Z-48  
(2014)

ZONING PLAN FOR:  
DAVID PEARSON COMMUNITIES  
PROPERTY IS LOCATED IN LAND LOT 629 & 630  
IN THE 16TH DISTRICT, 2ND SECTION  
COBB COUNTY, GEORGIA  
SCALE: 1" = 50'  
DATE: APRIL 21, 2014  
REVISED: JULY 24, 2014

**PETITION NO:** Z-48

**ZONING COMMENTS:**

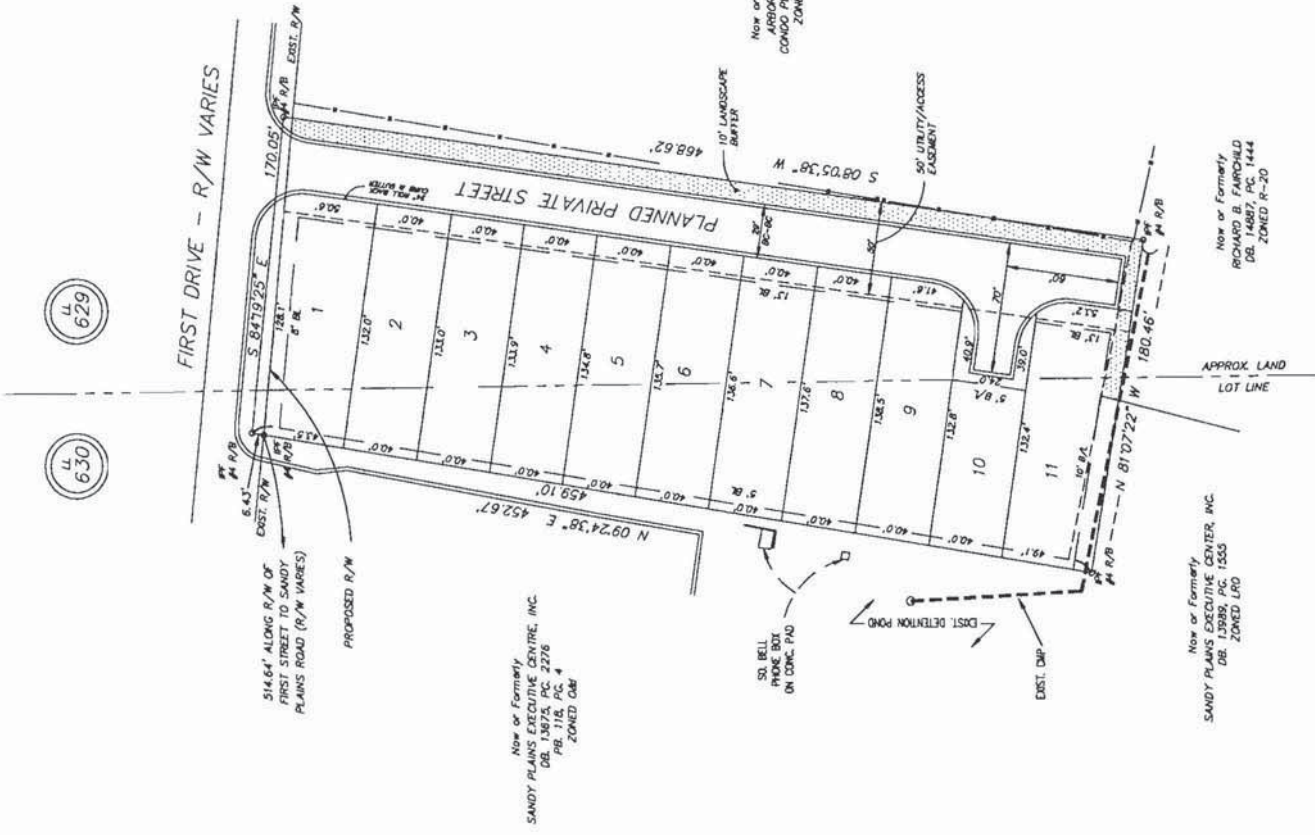
The site plan indicates a private street is planned and the applicant requests that the setbacks for the development be geared toward the private street, instead of First Drive. This will require granting a waiver of the front setback along the private street from 25 feet to 13 feet; waiving the rear setback abutting the eastern property line from 35 feet to 20 feet.

When projects contemplate less than 20 foot separation between units, guest parking shall be provided or the streets shall be labeled as a fire lane.

Additional Comments: Master meter to be set at public ROW

Additional Sewer to be private in private street  
Comments:

- Provide comprehensive hydrology/stormwater controls to include development of out parcels.
- Submit all proposed site improvements to Plan Review.
- Any **spring activity** uncovered must be addressed by a qualified geotechnical engineer (PE).
- Structural fill \_\_\_\_\_ must be placed under the direction of a qualified registered Georgia geotechnical engineer (PE).
- Existing facility.
- Project must comply with the Water Quality requirements of the CWA-NPDES-NPS Permit and County Water Quality Ordinance.
- Water Quality/Quantity contributions of the existing lake/pond on site must be continued as baseline conditions into proposed project.
- Calculate and provide % impervious of project site.
- Revisit design; reduce pavement area to reduce runoff and pollution.

1. This site is located on First Drive between Sandy Plains Executive Center to the west and the Arbor Oaks Suburban Condominium development to the east. The entire site drains to the east through the Arbor Oaks development. With the proposed layout a drainage easement will be required along the rear of all the lots to adequately control runoff from the site. Since it appears that underground detention will be utilized under the private street, it may be necessary to relocate the street to the low-side of the site, adjacent to Arbor Oaks, to adequately control site runoff.

2. The detention pond for the adjacent Sandy Plains Executive Center discharges through an existing pipe along the southern boundary of this site. An adequate drainage easement must be provided for this conveyance.

3. Since private streets are proposed all stormwater management within the development including the detention facility will be privately maintained in perpetuity by the HOA.

First Drive is classified as a local and according to the available information the existing right-of-way does not meet the minimum requirements for this classification.

Recommend applicant consider entering into a development agreement pursuant to O.C.G.A. 36-71-13 for dedication of the following system improvements to mitigate traffic concerns: a) donation of right-of-way on the south side of First Drive, a minimum of 25' from the roadway centerline.

Recommend curb, gutter, and sidewalk along the First Drive frontage.

Recommend private streets be constructed to the Cobb County Standard Specifications.

Based on the above analysis, Staff recommends DELETING the request to RA-5 subject to the following conditions:

- Site plan to meet all RA-5 requirements;
- Detached, single-family houses only;
- Fire Department comments and recommendations;
- Water and Sewer Division comments and recommendations;
- Stormwater Management Division comments and recommendations;
- Department of Transportation comments and recommendations; and
- Owner/developer to enter into a Development Agreement pursuant to O.C.G.A. §36-71-13 for dedication of system improvements to mitigate traffic concerns.
